DOCKET 50-255 - LICENSE DPR-20 -  
PALISADES PLANT - RESPONSE TO  
ADDITIONAL INFORMATION FOR  
DEGRADED GRID VOLTAGE

REQUEST FOR ADDITIONAL INFORMATIONPalisades Plant  
Degraded Grid VoltageItem 1

Figure 1

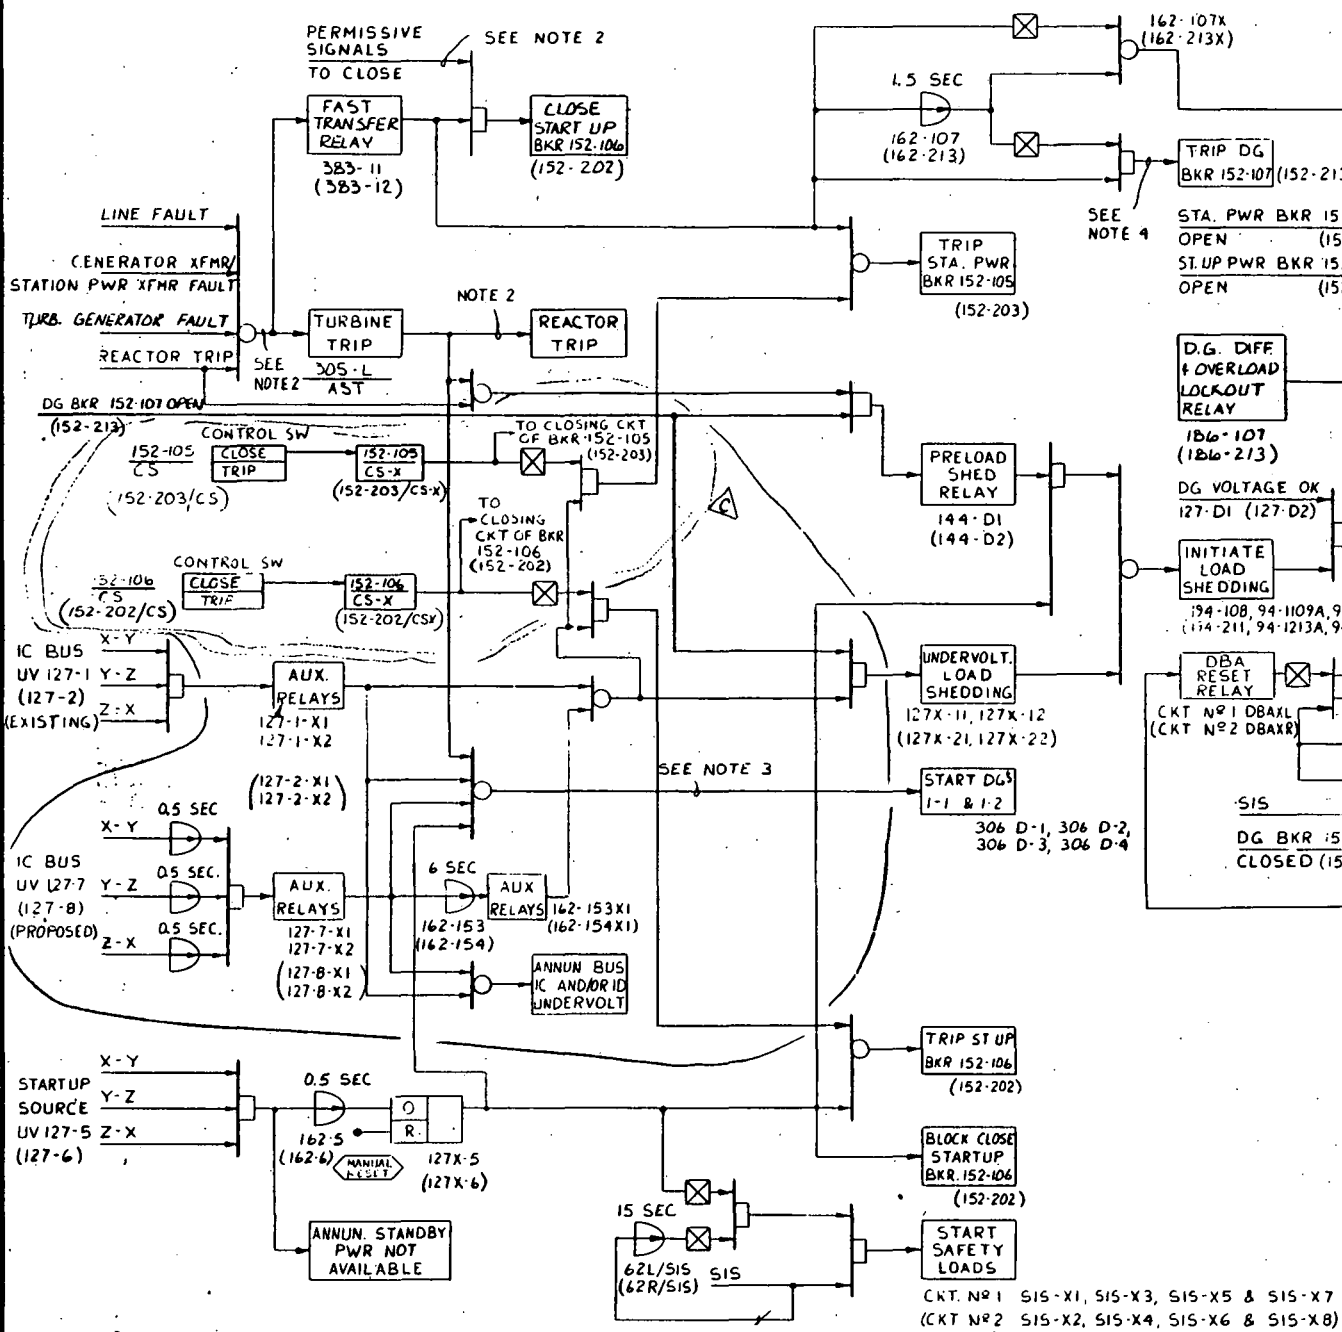
Please explain why your choice of a 3/3 coincident logic is acceptable from a safety standpoint (as contrasted to a 2/3 coincident scheme). Schematics of the proposed relaying circuits and types of relays being used are also requested.

A Bechtel review has indicated that the 3 out of 3 logic is to be preferred for the following reasons:

1. Historically the off-site (grid) power sources have been known to have a high degree of availability and reliability. It is, therefore, necessary to ensure that the high level of availability is not degraded due to unintentional trips such as might be caused due to PT fuse blowing.

Three out of 3 logic prevents the maloperation of the proposed undervoltage scheme when a single fuse blows out in the 120 V a-c potential transformer secondary circuit. Such maloperation will lead to unwanted trip of the off-site power source ACBs and the transfer of the safety-related buses to the on-site emergency diesel generators.

2. The existing undervoltage protection scheme for the 2400 V safety-related buses 1-C and 1-D utilizes 3 out of 3 logic. To be consistent, it is preferable to use 3 out of 3 logic for the proposed addition, also.

The enclosed Figure 1 is the proposed relaying circuit scheme to be used at the Palisades Plant.
